Re: Record of Decision for SEADs-3, 6, 8, 14 and 15, known as the Ash Landfill at the Seneca Army Depot Activity Superfund Site, Romulus, New York

**FINAL**  
**RECORD OF DECISION (ROD)**  
**THE ASH LANDFILL OPERABLE UNIT**  
SENECA ARMY DEPOT ACTIVITY

**RESPONSE TO EPA AND NYSDEC COMMENTS**

**FIGURE 1-1**  
**EXTENT OF ASH LANDFILL**  
**LAND USE CONTROLS**

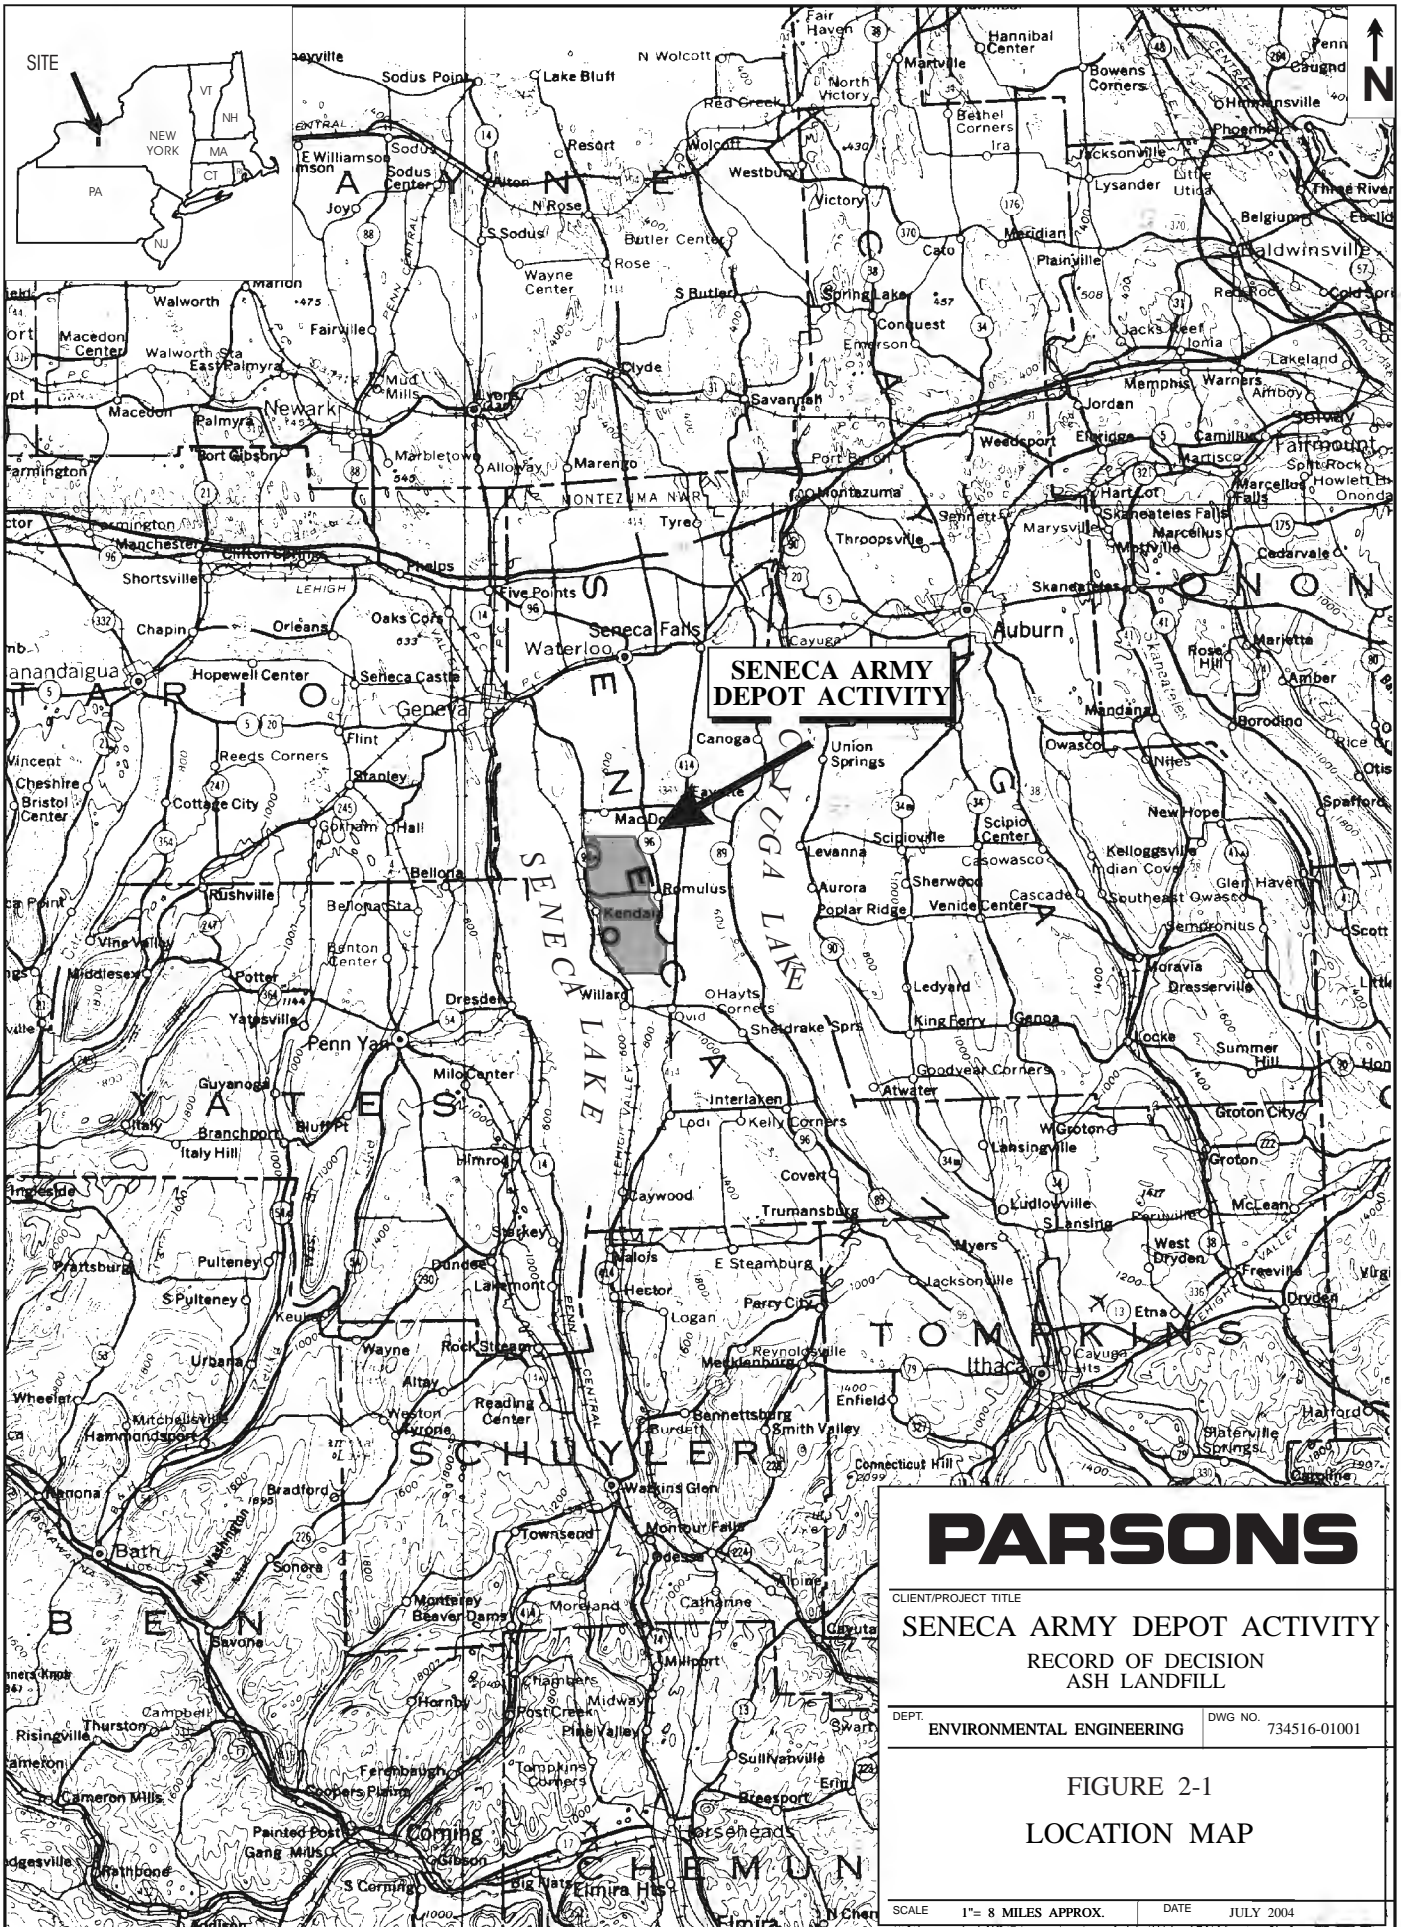
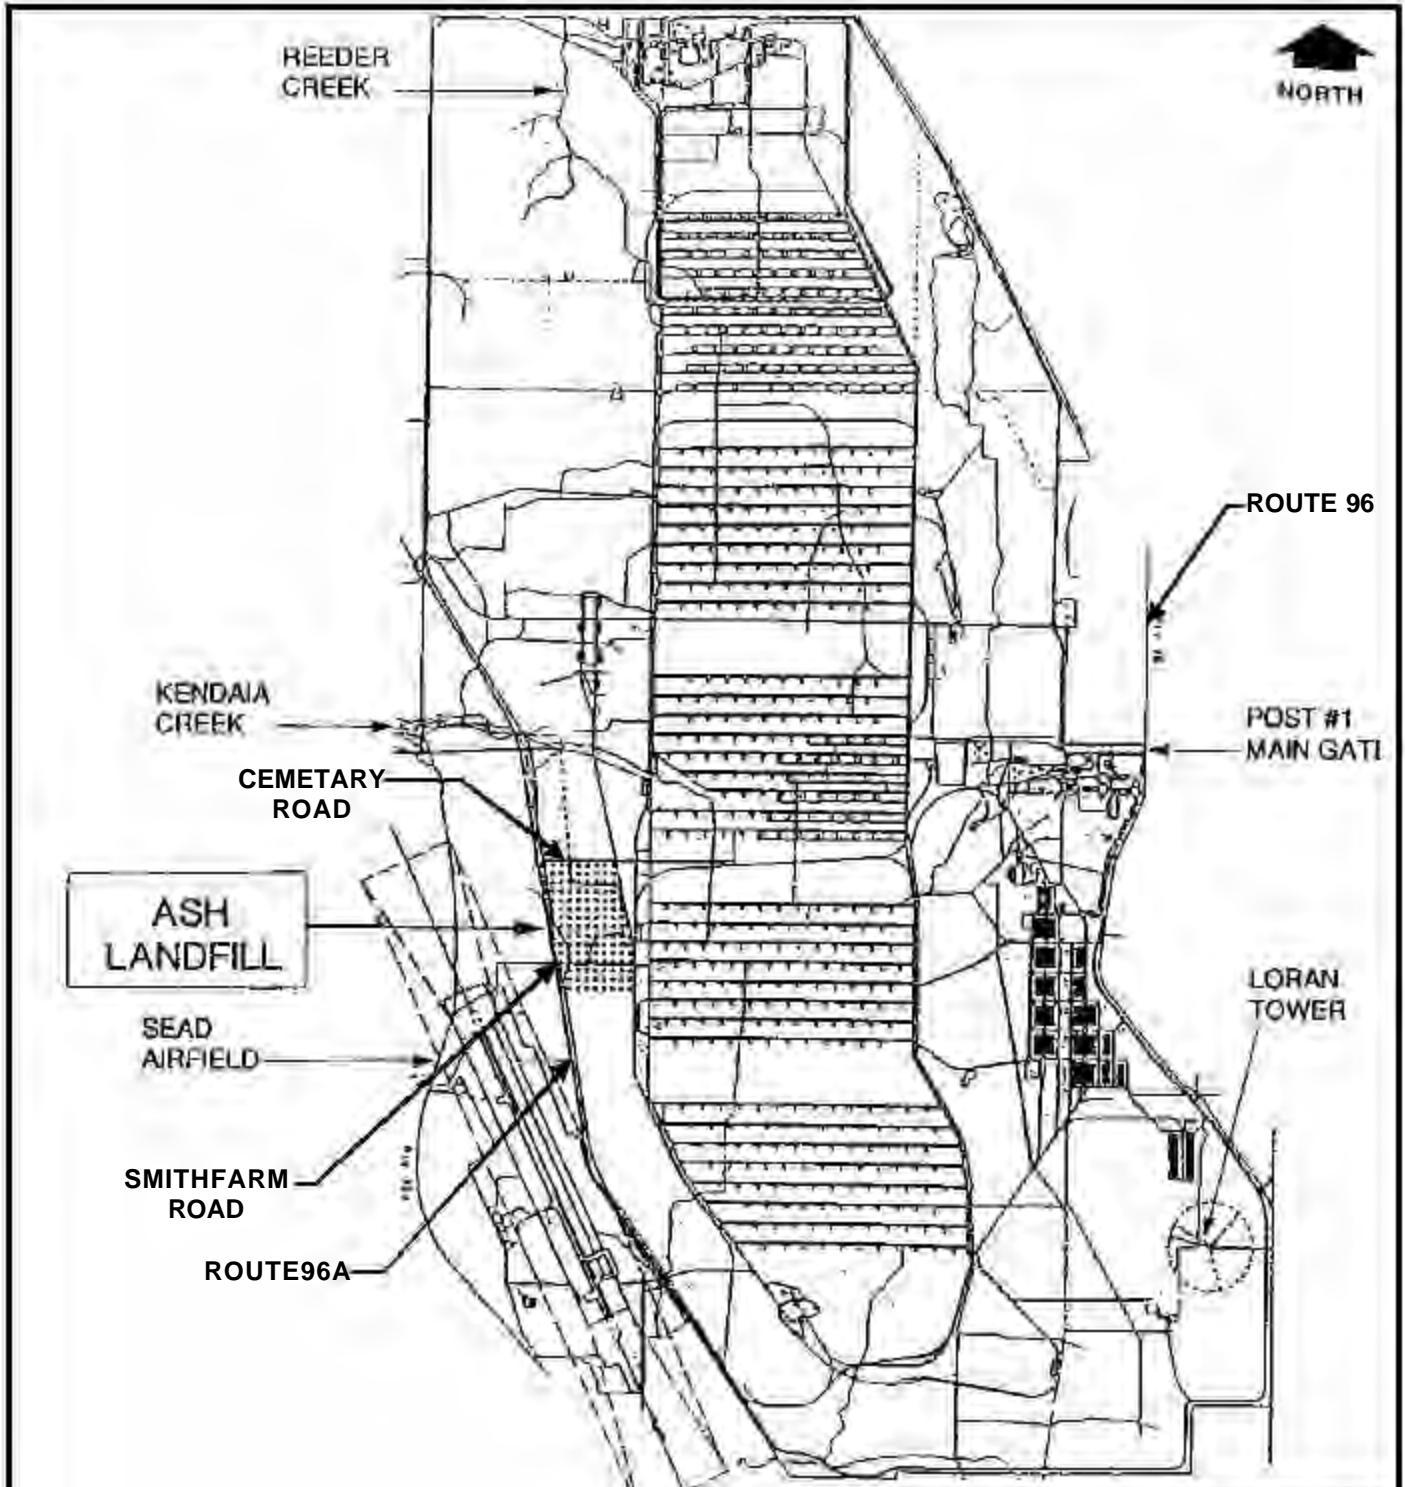
- 3) Include a figure showing the boundaries of the LUCs.
- 4) Note that the above LUC modifications are also applicable to Section 5.0, page 5-1 and Section 11.0, page 11-1.

- 3) Agreed. A new figure (Figure 1-1) has been added to show the proposed extent of the LUCs at the Ash Landfill.
- 4) Agreed. Comparable modifications have been made in Section 5.0 and 11.0.

**FIGURE 11-1  
EXISTING AND PROPOSED  
REACTIVE BARRIER  
WALL TRENCHES**

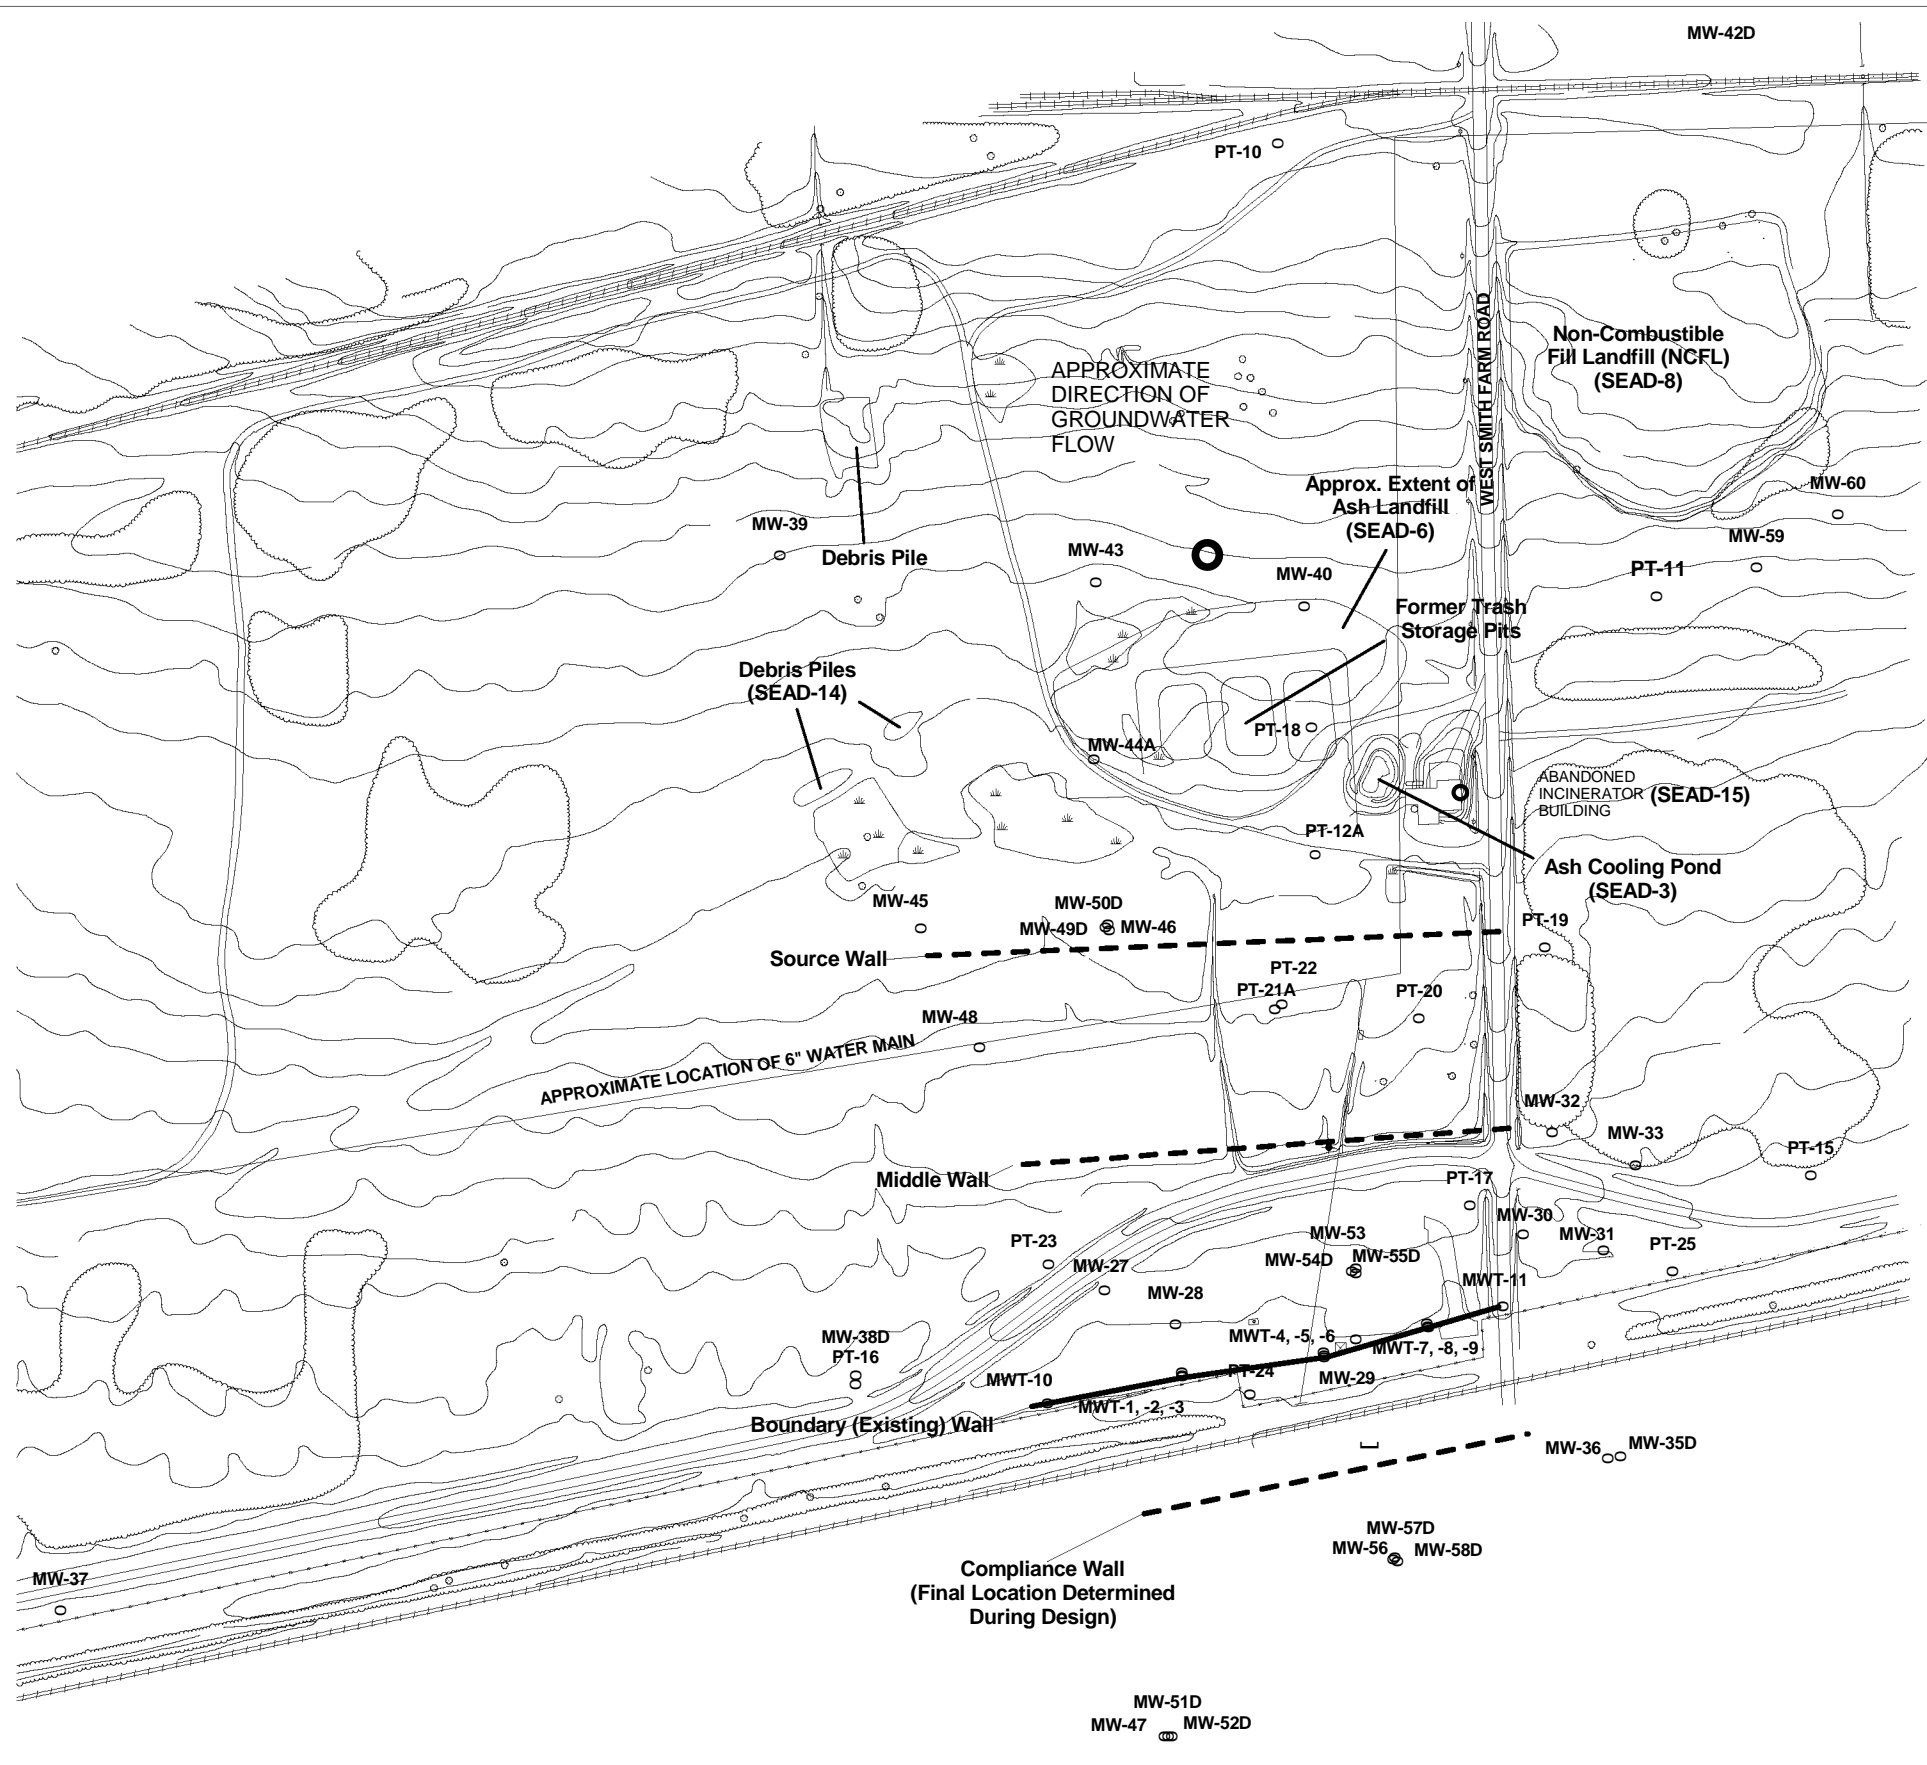
**Comment 26:** Figure 11-1: This figure did not reproduce well and there is a typographical error in the title.
